**MEMOCORP
AUSTRALIA PTY LTD**
(ABN 57 051 213 803)

10th February 2011

Re: City One - Thakral House/Wynyard, Proposed Wynyard Station Upgrade and Commercial and Retail Development – Land between George, Margaret and Carrington Streets, Sydney (MP09_0076)

Figure 46 – Martin Place Sun Access Plane - section

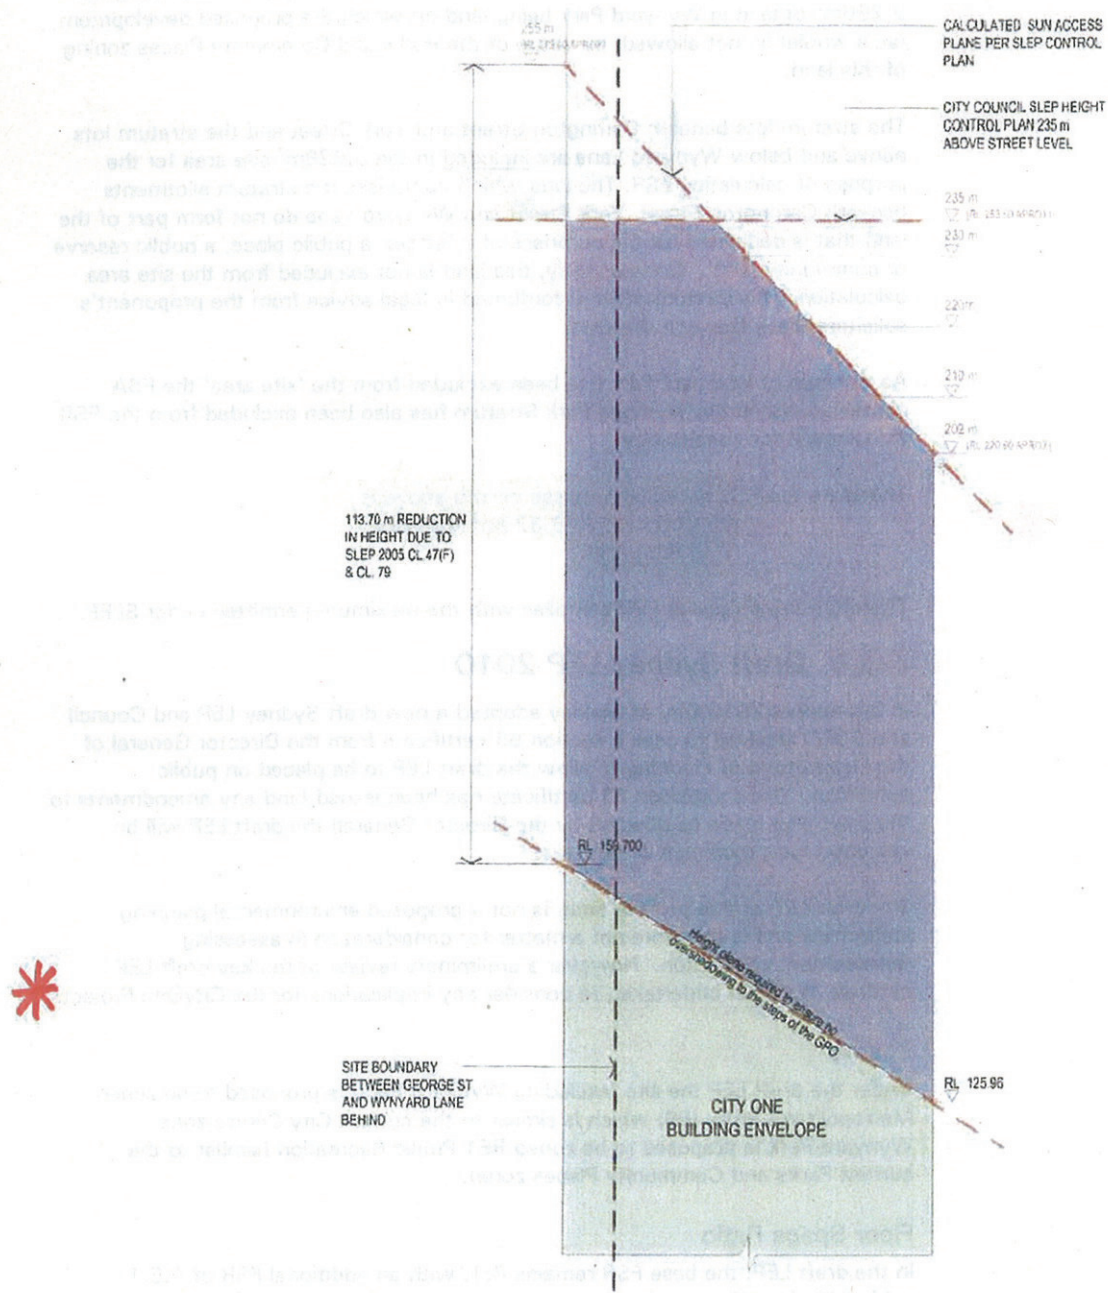
Height	RL 159.70 to RL 125.96m (refer to enclosed Attachment B, JBA EAR, Pg 82 & 83)
Permissible	55 m (Carrington Street portion of the site)

DoP should reject the placement of the proposed City One tower envelope exceeds the permissible 55 metre building height for both the Carrington street and main part of George Street frontage between 57 to 91 metres.

The proposed RL 159.70 to RL 125.96m height is excessive in bulk, scale and height fronting both Carrington Street and Wynyard Park, and do not have a desirable character of the development to be integrated to existing scale including historic neighbours along the Carrington Street. It's does not provide the adequate transition of the building height between surrounding localities and do not provide adequate levels of daylight to narrow street especially Wynyard Lane.

The tower development fronting the Carrington Street should be lowered to maximum permissible height of 55m, retain the existing same amount of daylight into the Wynyard Park (Special Area in Schedule 6) and also all the public domain.

Figure 47 – Comparative heights (Source: Hassell)

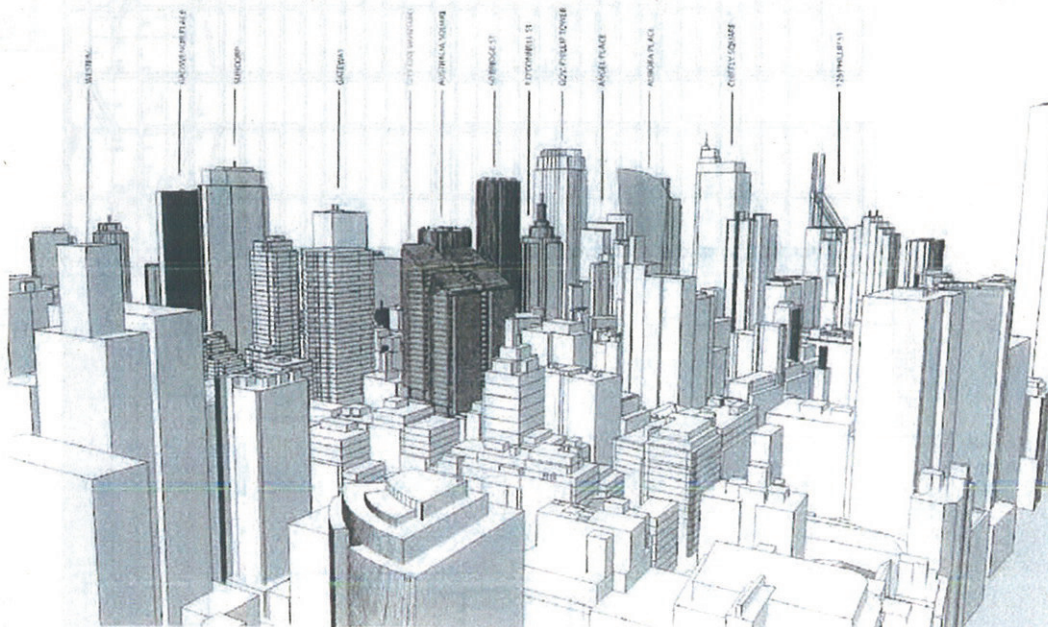
This proposed commercial tower is not in keeping with the scale around the Wynyard Park.

We lost of eastern district view due to this excessive overly tall and bulky building envelope which poses severe overlooking concern to both us and surrounding buildings.
